MODIFIED LOOP OSCILLATOR BOARD [PTOS110A0X] ± 5kHz

DRAWN BY Rick Jackson Euro Radio Co		
File	CYBERNET PTBM121D4X AMFMSSB PART 2	
Size	Document Number PTBM121D4X_SWITCHING_OFFSET_OSC.SCH	
Date	Wednesday, October 22, 2008	Sheet 2 of 2

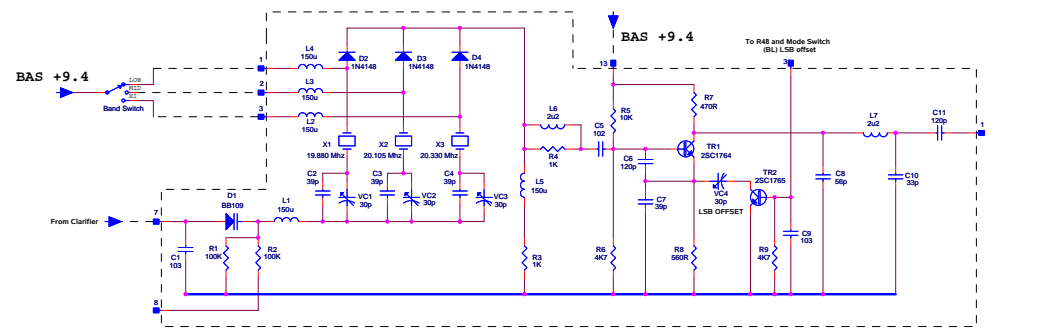
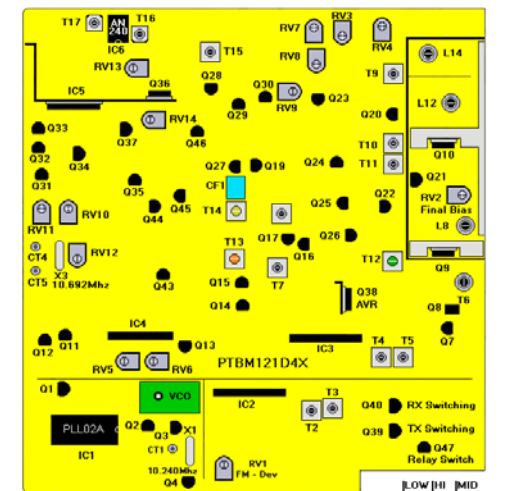
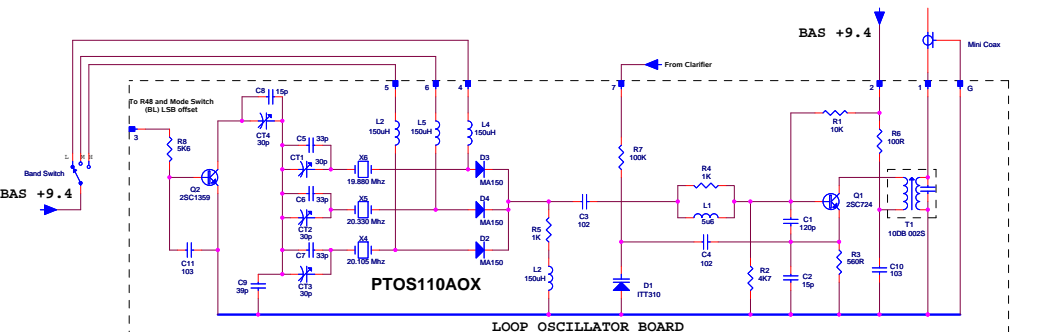
SSB TX Audio
 All Cybernet 121D4X boards suffer with distorted 'gritty' sounding audio on SSB. This was caused by a low bias in the RF output stage, which caused the outgoing signal to distort. As a transistor requires a minimum of around 0.6 volts to conduct, signals below this level are clipped unless the transistor is biased to conduction with a constant dc current.

SSB for TX Audio
 The cure for this problem is to increase the bias. As the bias adjustment (RV2) will not usually take the bias high enough, a resistor will need to be changed.
 1. Replace R44 10 Ohm bias resistor with an 18 Ohm.
 2. Set mode to USB, connect DC milliammeter between Q10 emitter and ground and adjust RV2 for 50mA.
